Freshwater Mixed Use Development

50 Lawrence Street
Freshwater, NSW

Development Application
SEPTEMBER 2021

LIST OF CHANGES:

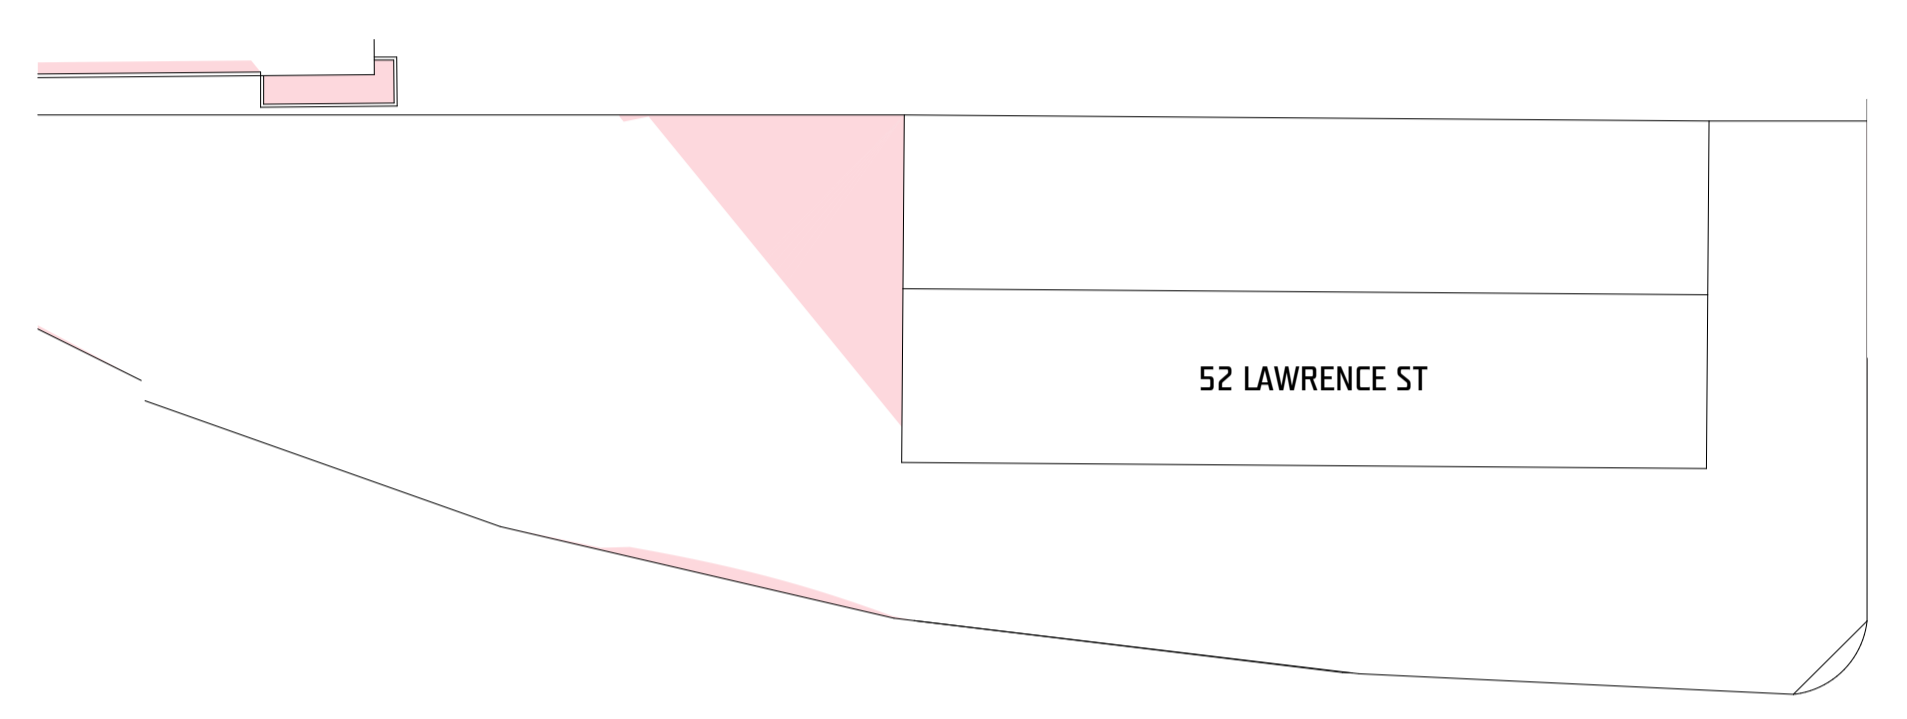
M: Neighbouring Property- Existing garage added to plans for clarity.

June Shadows 12Noon
SCALE 1:250 @ A1

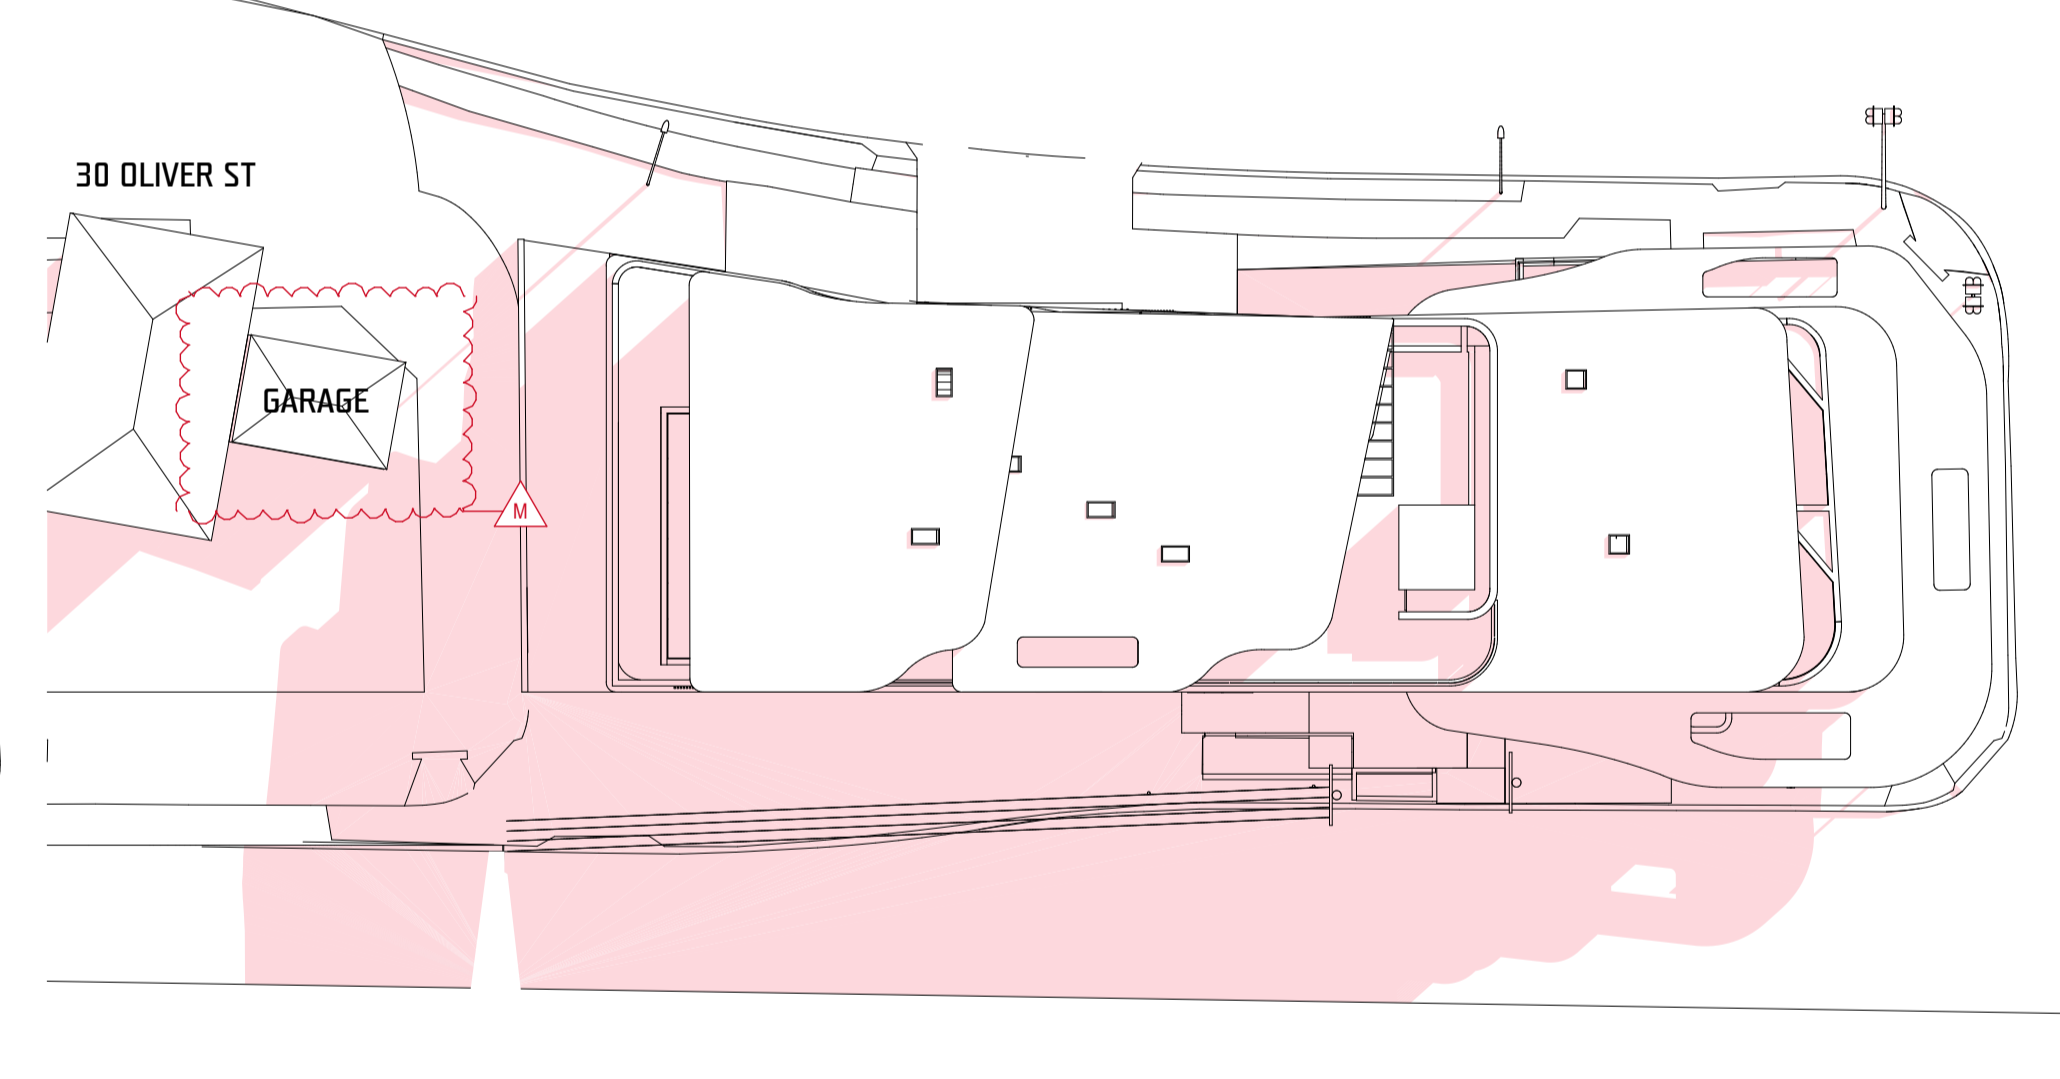
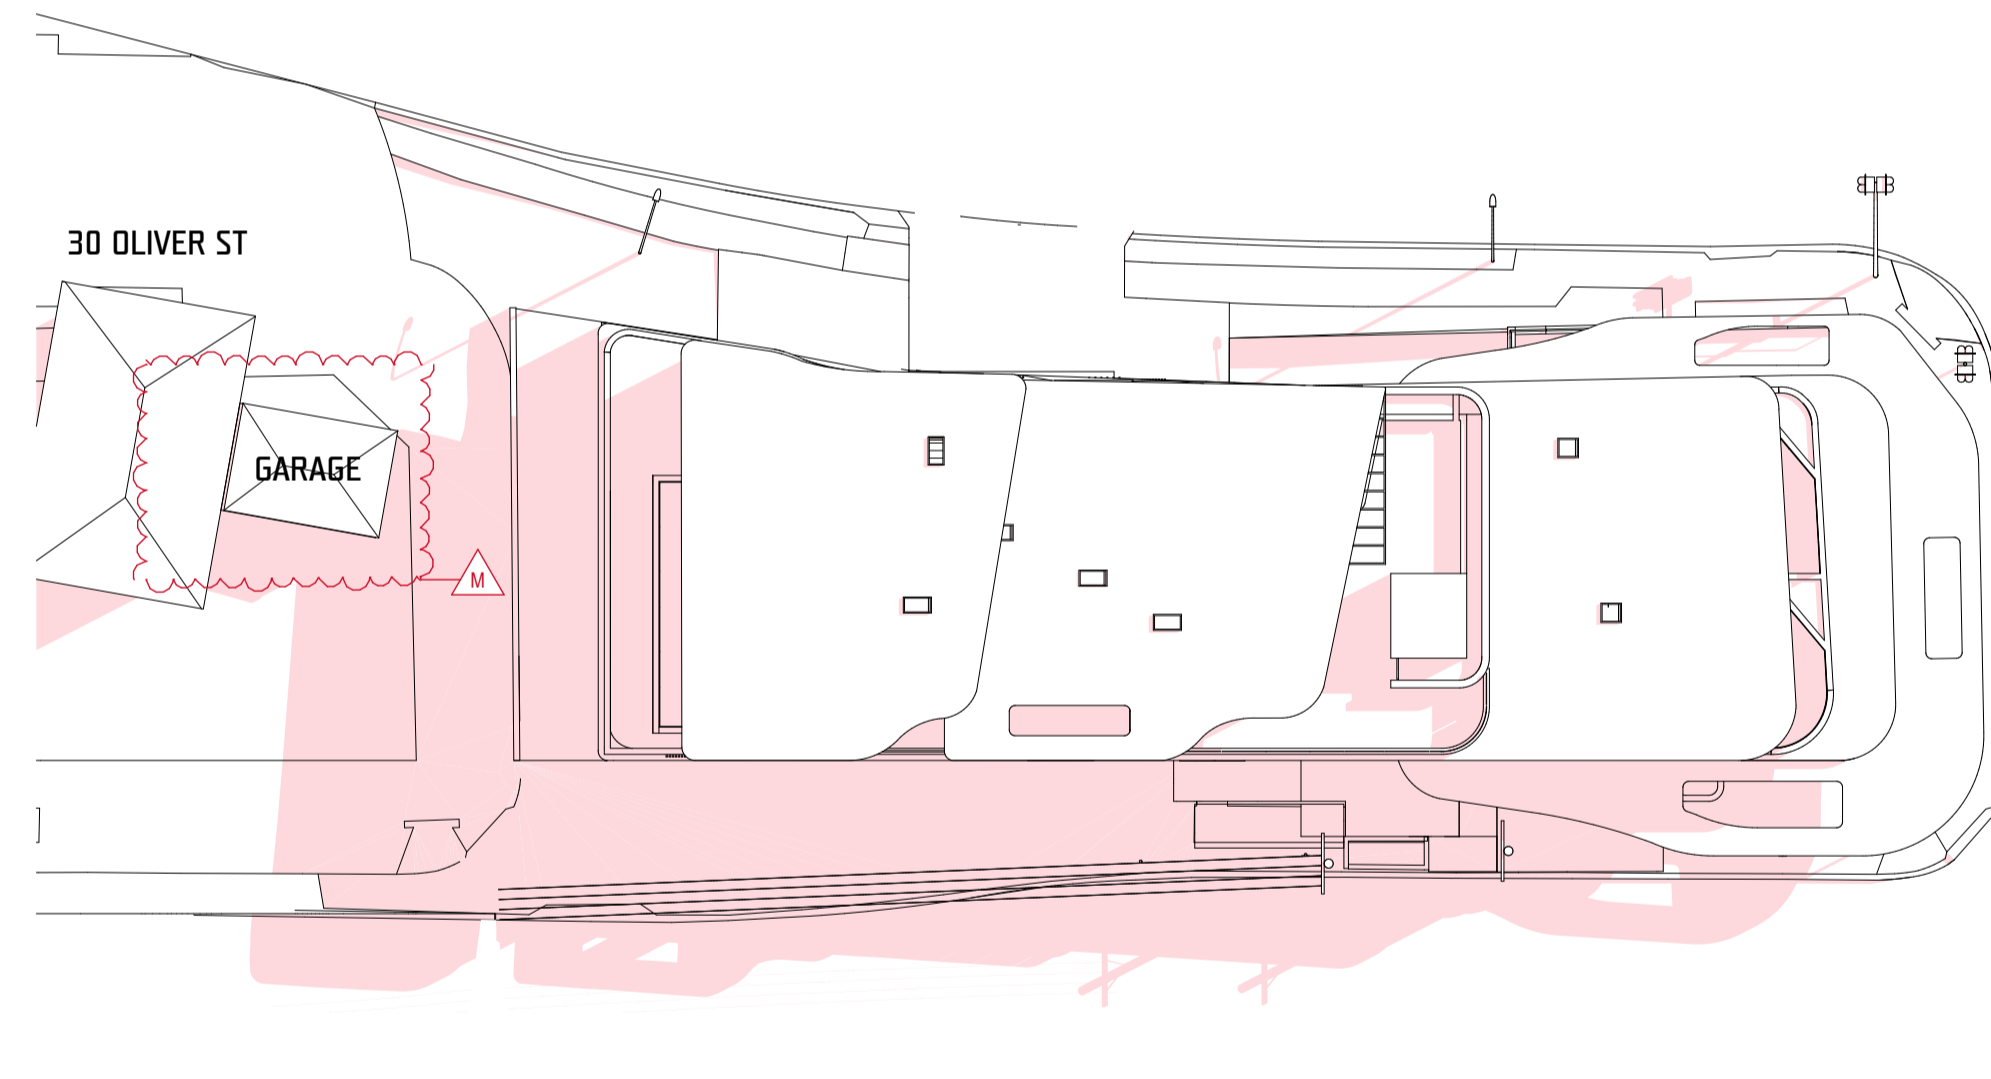
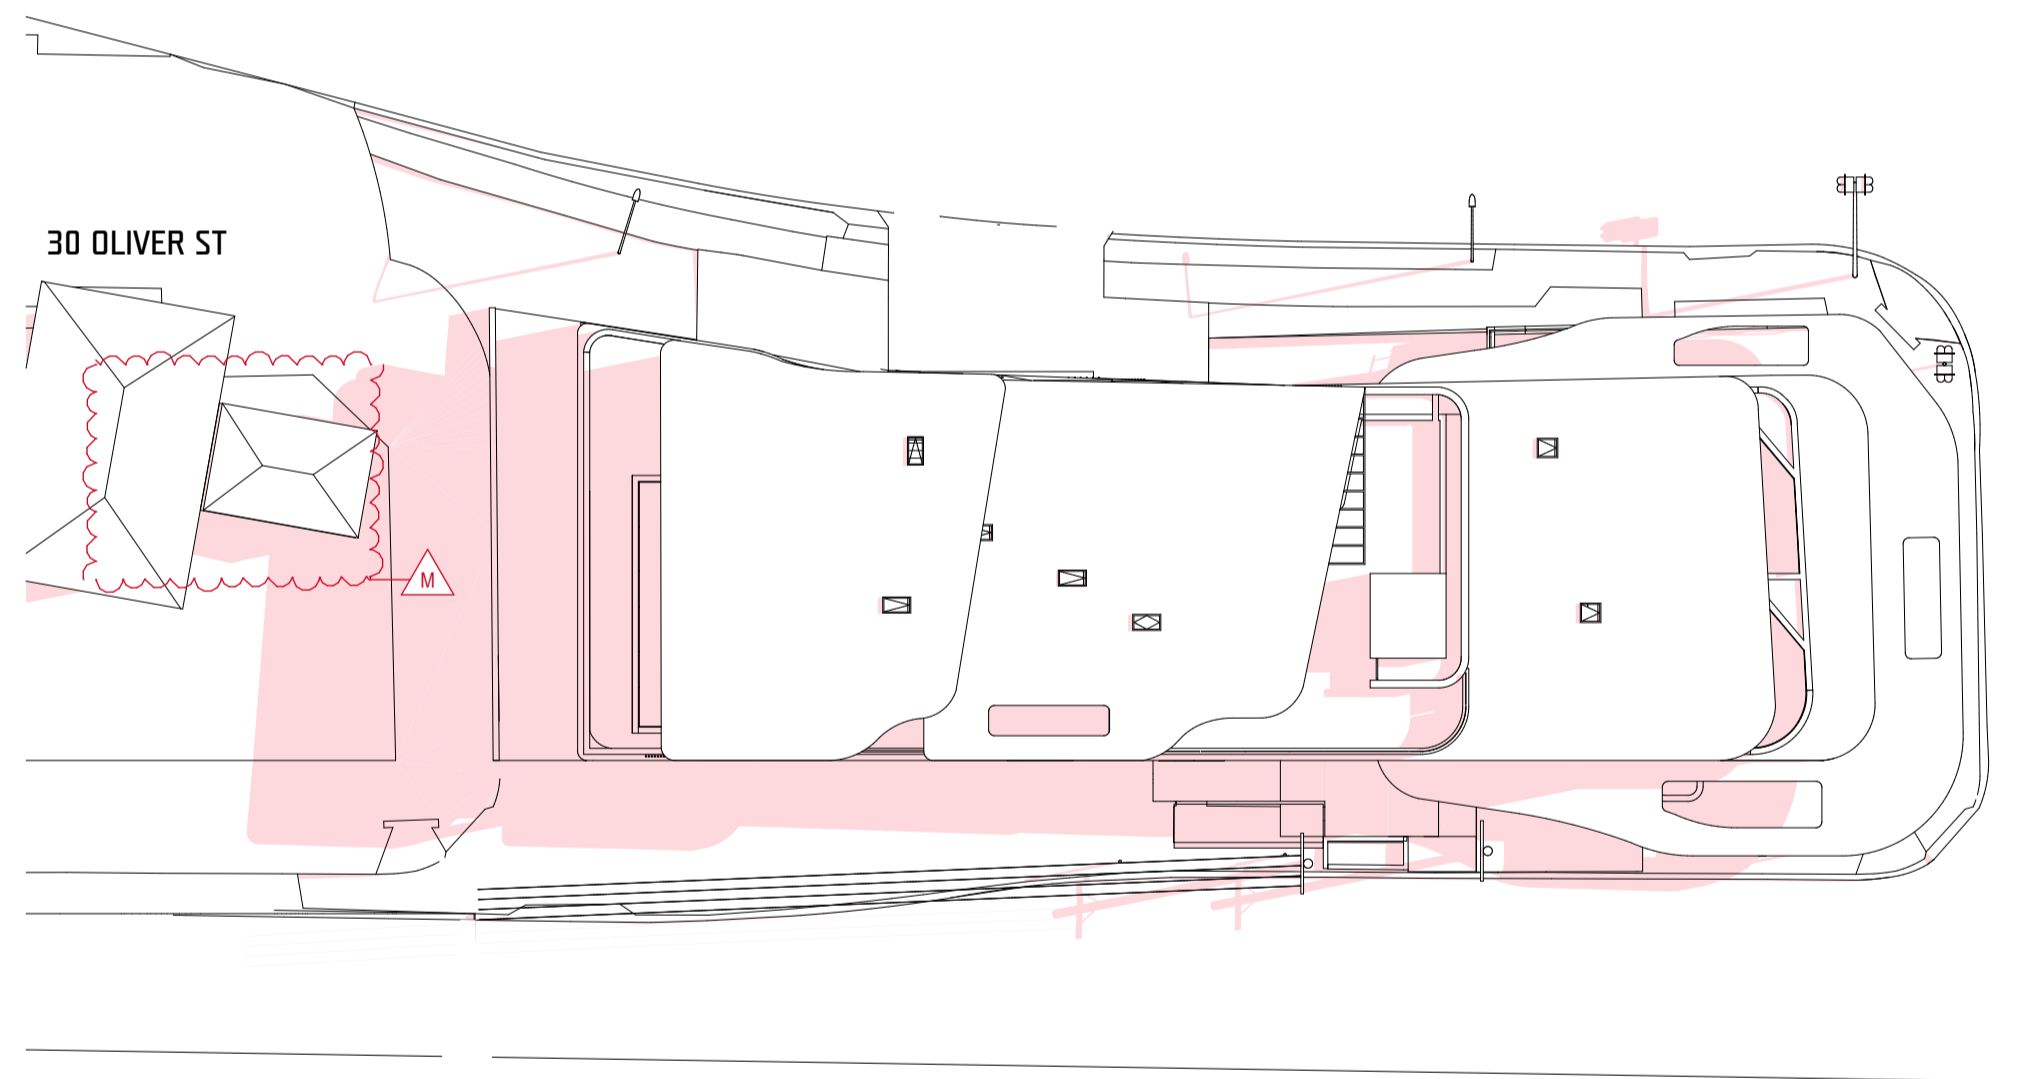
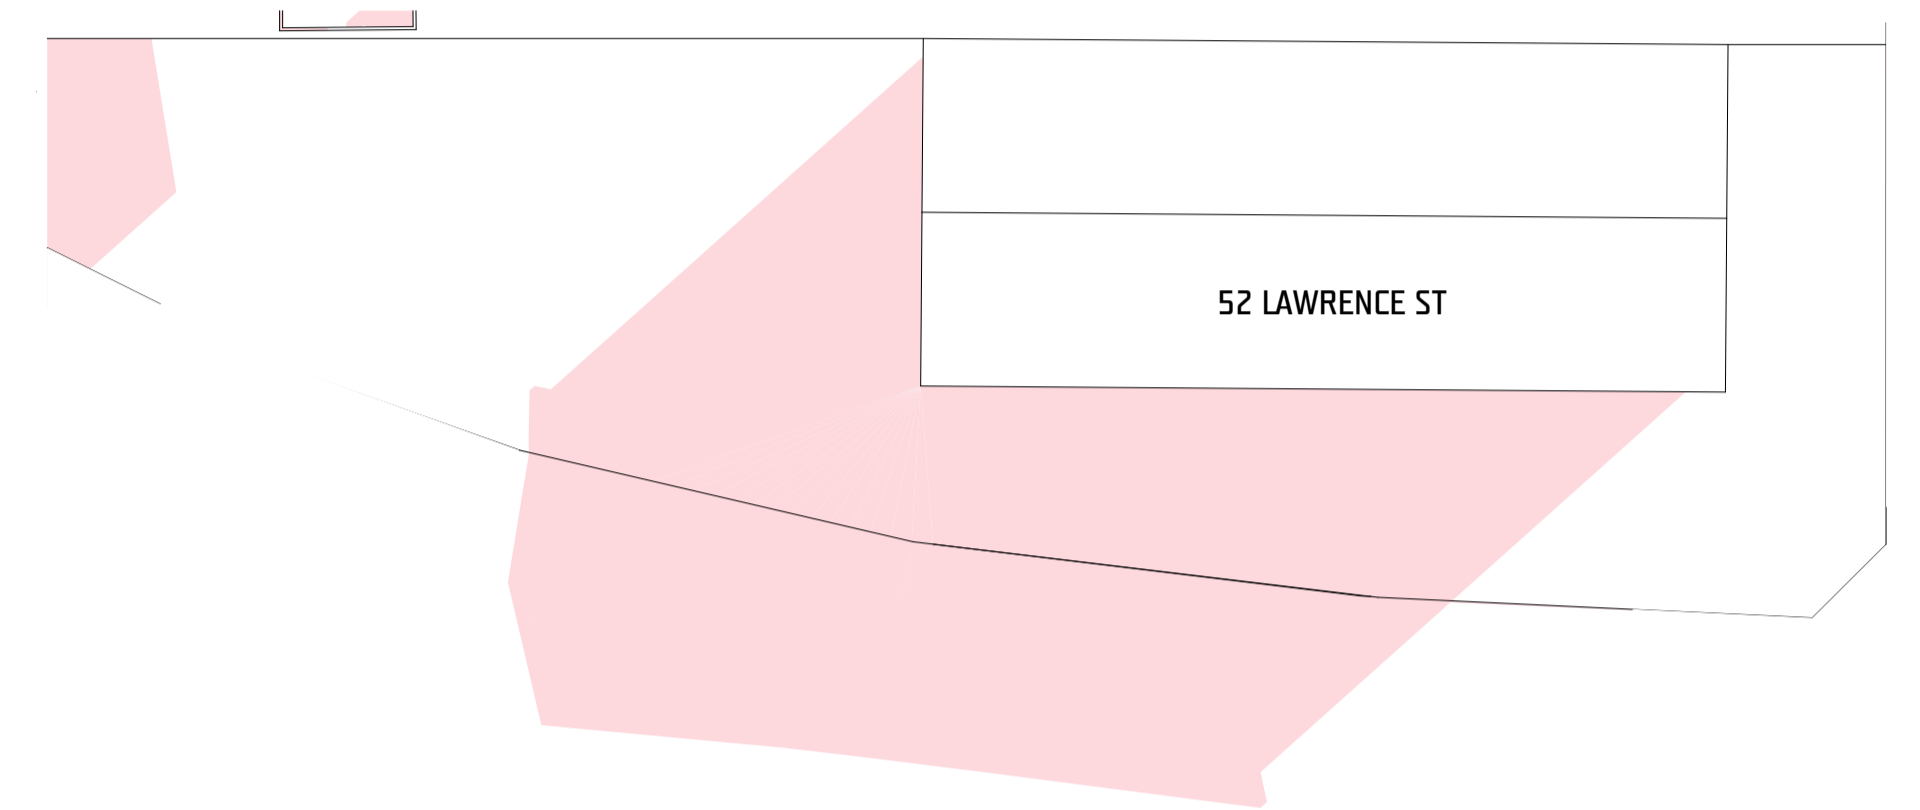
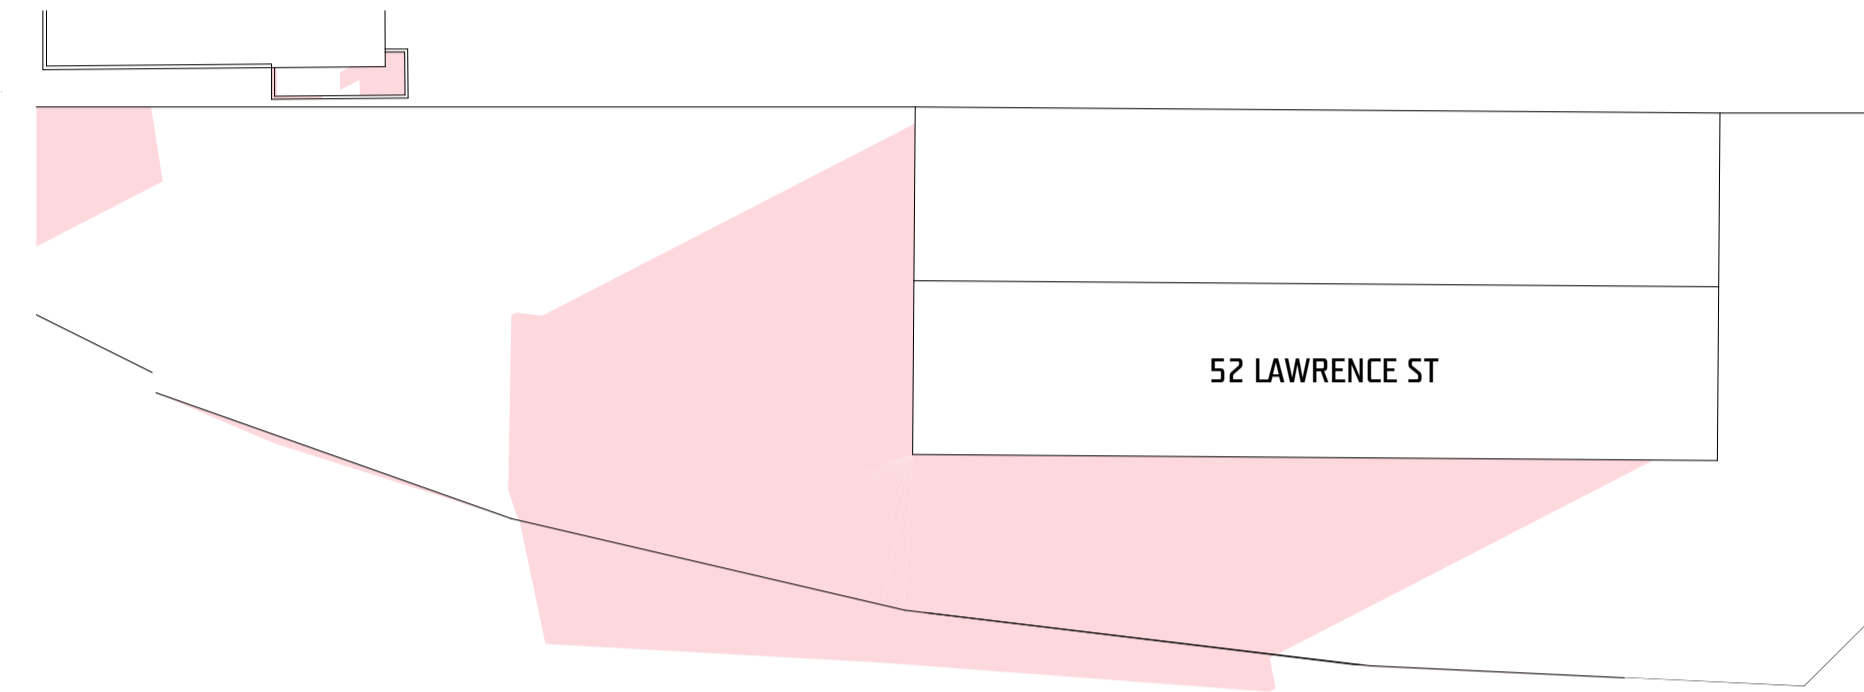
M: Neighbouring Property- Existing garage added to plans for clarity.
